**STAFF ANALYSIS  
OF THE  
WHITE ROSE PRODUCTION VOLUME INCREASE  
DEVELOPMENT PLAN  
AMENDMENT APPLICATION**

On September 29, 2006, Husky Oil Operations Limited (Proponent) submitted the document *White Rose Development Plan Amendment Production Volume Increase (September 2006)* (the Document) to the Canada-Newfoundland and Labrador Offshore Petroleum Board (Board) on behalf of the owners in Production Licence (PL) 1006. The Document proposes to increase both the Annual Oil Production Rate (AOPR) and Facility Maximum Daily Production Rate (FMDPR) from 100,000 barrels of oil per day (bopd) (15 900 m<sup>3</sup>/d) as stated in the approved White Rose Development Plan Decision 2001.01 to 140,000 bopd (22 261 m<sup>3</sup>/d). Any approval to increase the FMDPR must be made by both the Chief Safety Officer (CSO) and Chief Conservation Officer (CCO). The AOPR requires Board approval as well approval from Governments (fundamental decision)

Staff reviewed the Document and advised the Proponent that it constituted a Development Plan Amendment Application (the Application) and that additional information would be required to complete the Application. This information was subsequently s

**Figure 4. 1: White Rose Production History (Source: C-NLOPB)**

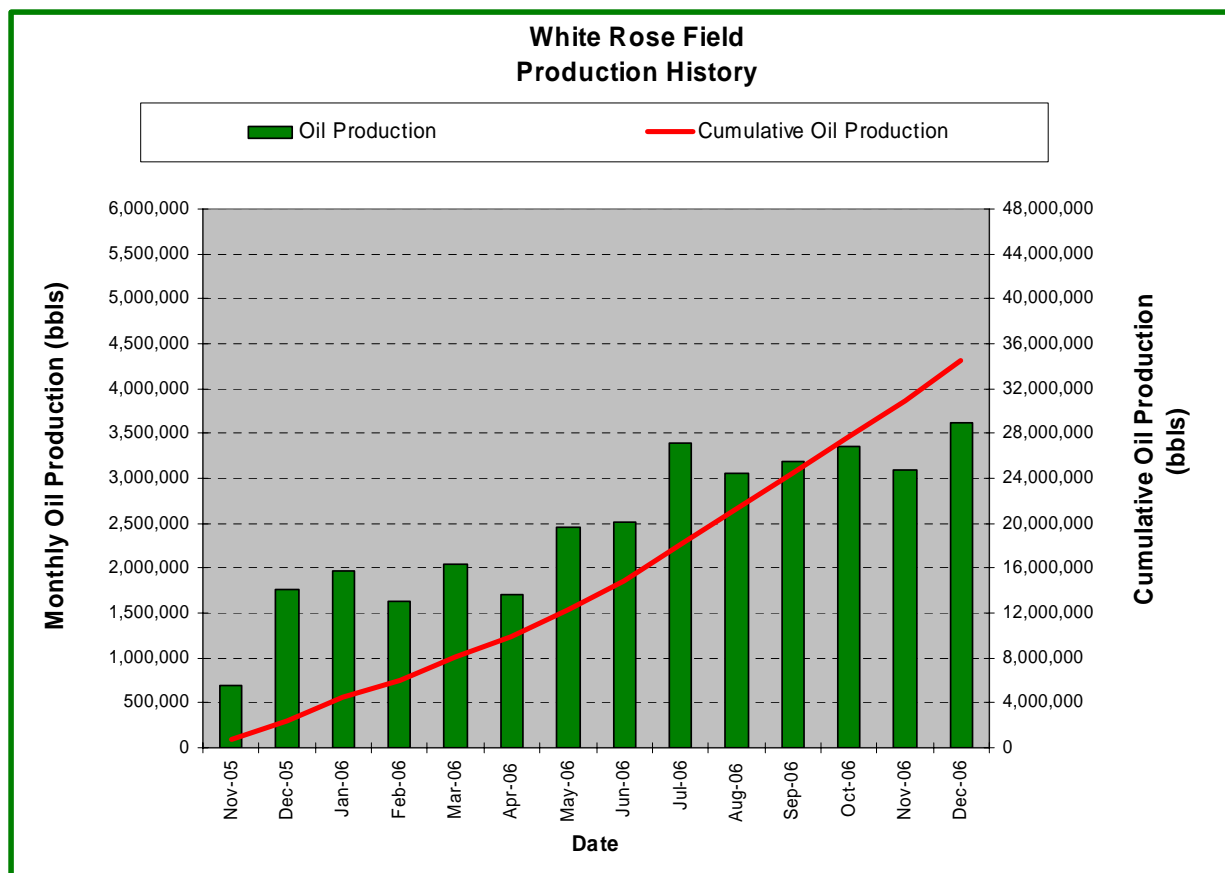
production facilities up to 125,000 bopd (19 875 m<sup>3</sup>/d) and plans further testing when sufficient production capacity is available. It should be noted, based on test results and information provided by the Proponent, that on September 29, 2006, the CCO and CSO approved a Facility Maximum Daily Production Rate (FMDPR) of 125,000 bopd (19,875 m<sup>3</sup>/d) and the facility has been producing above 100,000 bopd (15 960 m<sup>3</sup>/d) since approval (See Figure 4.1).

**Figure 4. 2: White Rose Field Actual vs. Simulation Oil Production Date (Source: C-NLOPB)**

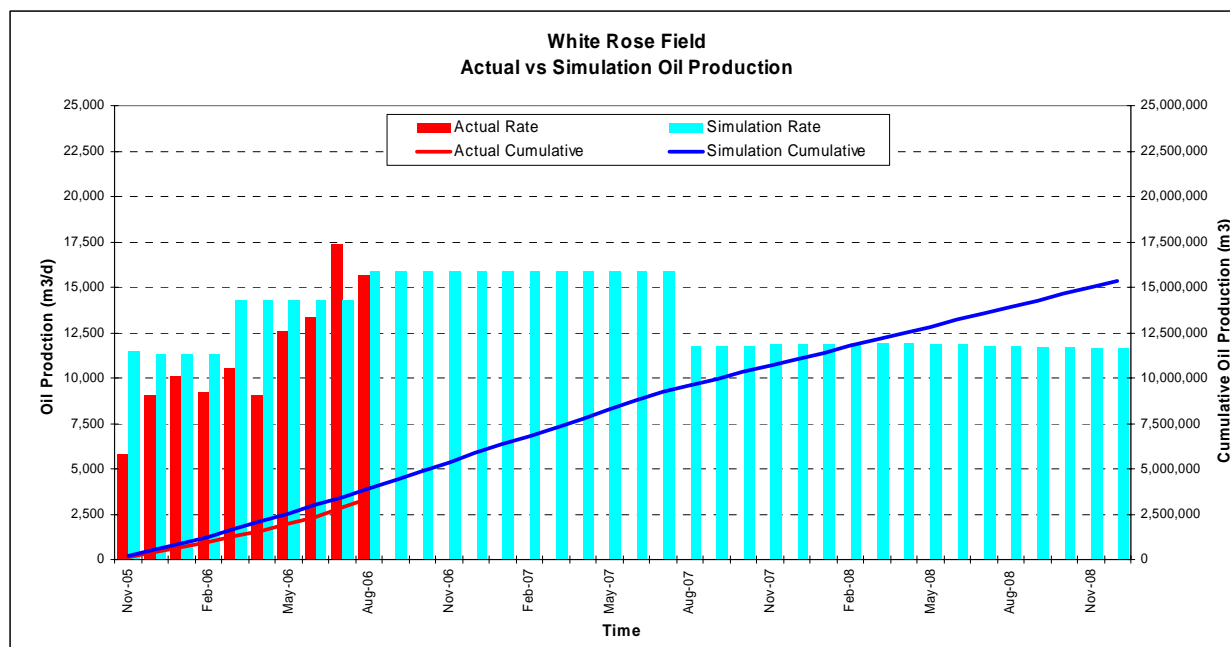
The comparison of actual versus simulation oil production shows that the White Rose Field production at the end of the history match period (late July 2006) has been following the simulation prediction. Early actual production did not match the simulation prediction due to normal operational start up issues (See Figure 4-2).

**Figure 4. 4: B-07 3 Actual vs. Simulation Oil Production (Source: C-NLOPB)**

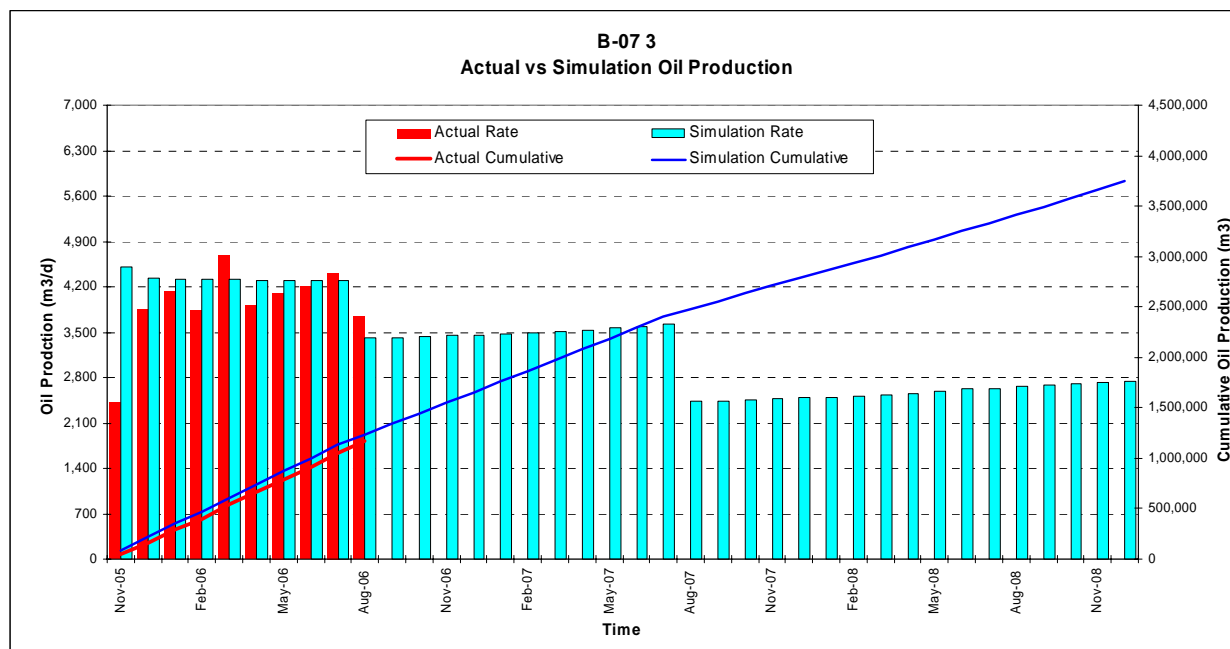
For example, Figure 4-4 shows the comparison of actual production from B-07 3 well with the simulation oil production. After initial start up operations, the actual data tracks the simulation.

**Figure 4.5: B-07 2 Actual vs. Simulation Oil Production (Source: C-NLOPB)**

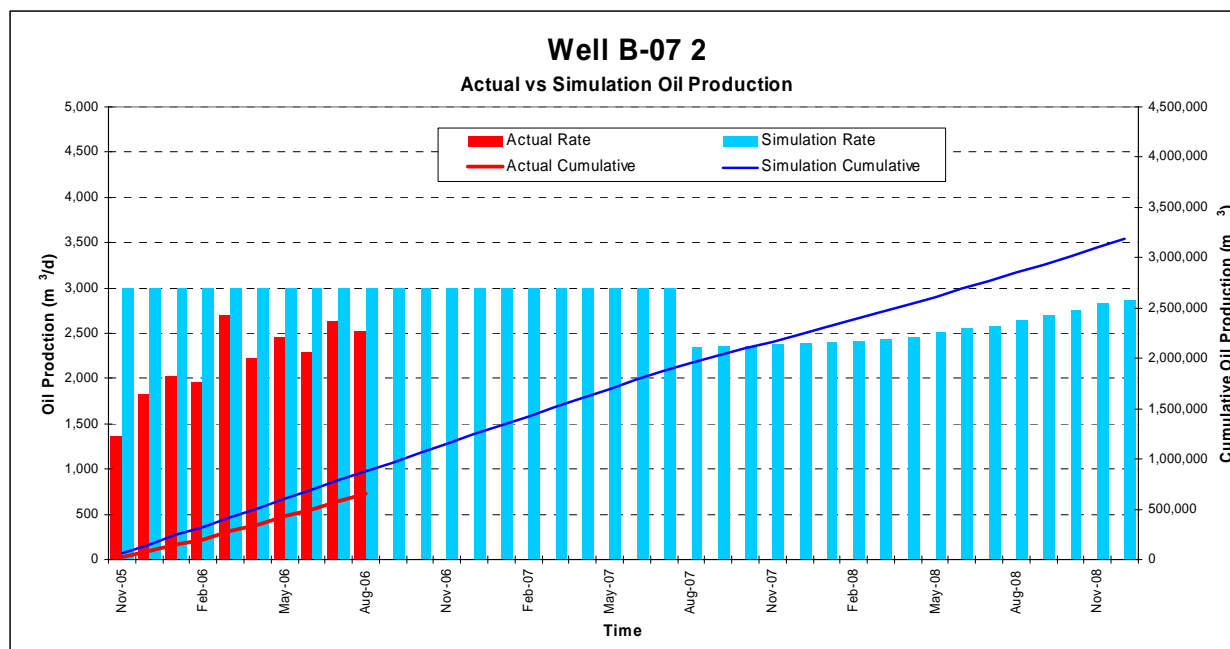
The B-07 2 well showed a slight difference between the actual and simulated production. At this well, the actual production performance (rates and bottom-hole pressures) were found to be less than that predicted from the simulation model (See Figure 4-5). It was determined by the Proponent that the contributing length in the well model B-07 2 needed to be adjusted to account for the overestimation of production in the Eclipse Reservoir simulation model. This adjustment provided a better history match with the actual production and pressure data from the first seven months of production data. Staff believes that the Proponent has made the appropriate corrections to the reservoir simulation in terms of the productivity of the B-07 2 well.

**Figure 4. 6: White Rose Oil Production Rate Comparison (Sealing Faults) (Source: C-NLOPB)**

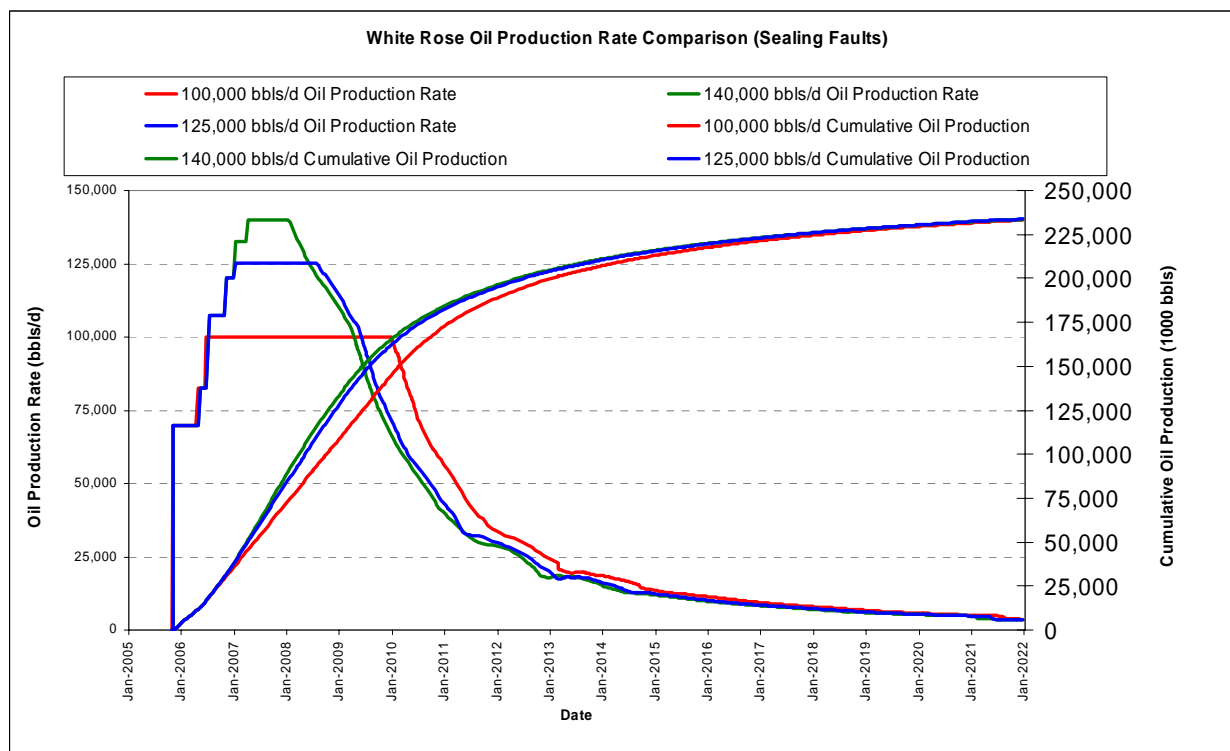
Figure 4-6 shows the average annual oil production rate forecast for each of the rate sensitivities evaluated by the Proponent for the South Avalon Pool development area (sealing faults case).

Figure 4.6 shows the effect of the proposed production rate increase on the life of the South Avalon Pool is minimal. Staff's simulation prediction shows that the end of life for this pool remains January 2022 and ultimate recovery is unchanged at 234 million barrels (37.2 million m<sup>3</sup>).

**Figure 4. 7: White Rose Oil Production Rate Comparison (Non-Sealing Faults) (Source: C-NLOPB)**

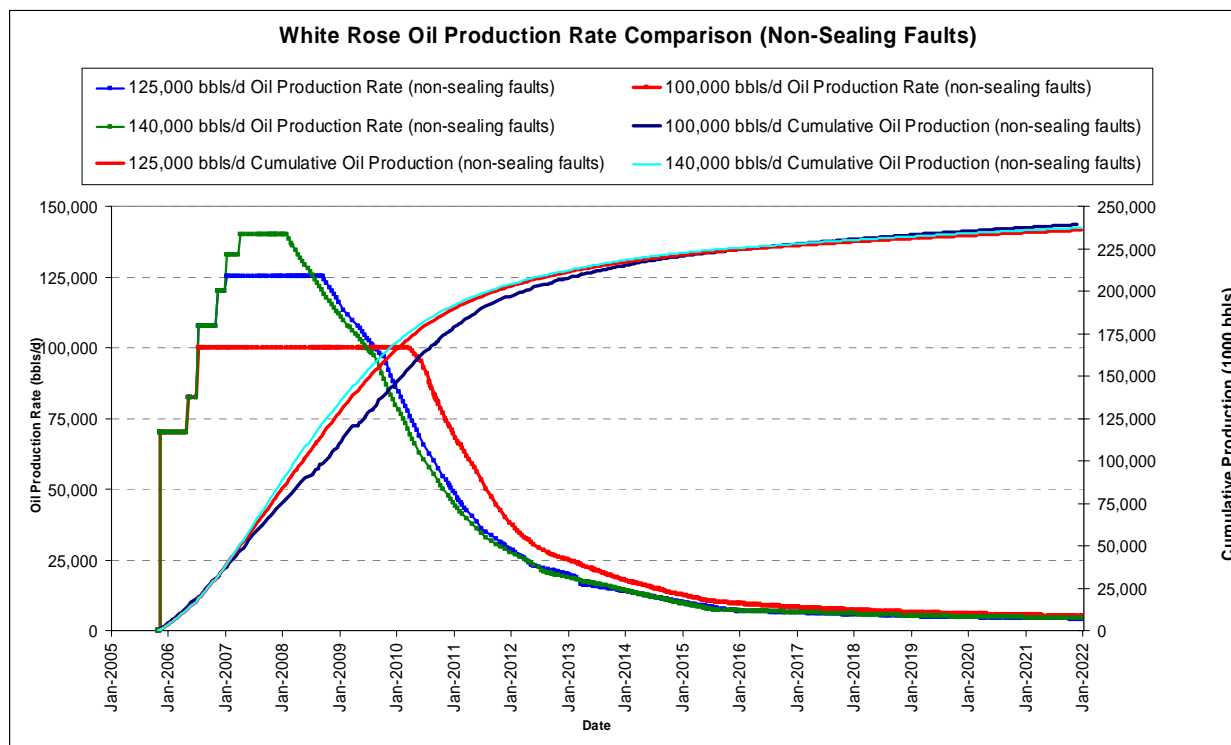
Figure 4-7 illustrates the average annual oil production rate forecast for the same rate sensitivities with a geological feature of non-sealing faults.

As seen from Figure 4-7, “non-sealing faults” simulation results are similar as the “sealing faults” simulation results.

**Figure 4. 10: White Rose Simulation Fluid Production Rate Increase Comparison (Source: C-NLOPB)**

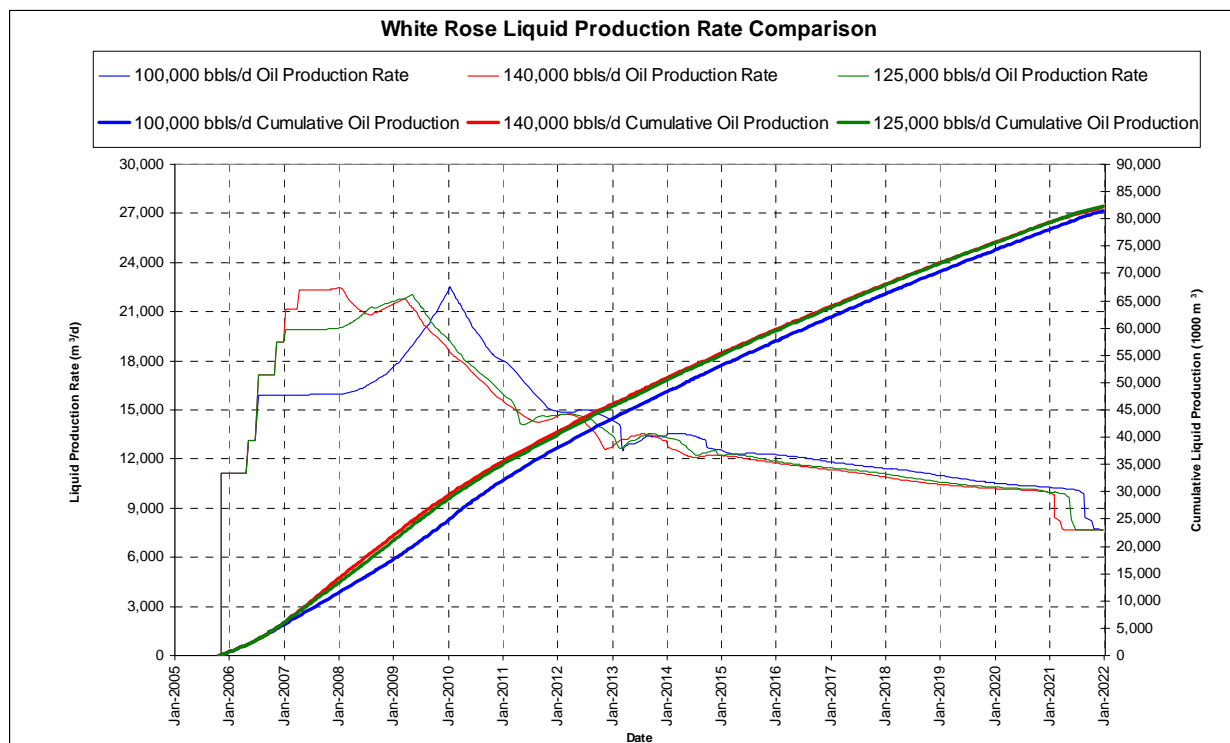
- The maximum field water rate achieved in all of the reservoir simulation sensitivities occurred at the end of the project at 21 000 m<sup>3</sup>/d when water production is expected to be at its highest. This is within the design requirements for the SeaRose FPSO of 28 600 m<sup>3</sup>/d.
- The total gas production rate does not exceed the design rate of 4.2 10<sup>6</sup> m<sup>3</sup>/d for the SeaRose FPSO at any of the simulated oil production rates. (See Figure 4.8)
- The total water injection rate does not exceed the design rate for the SeaRose FPSO of 46 000 m<sup>3</sup>/d at any of the simulated oil production rates. (See Figure 4.9)
- The total fluid production does not exceed the design rate for the SeaRose FPSO of 33 050 m<sup>3</sup>/d at any of the simulated oil production rates. (See Figure 4.10)
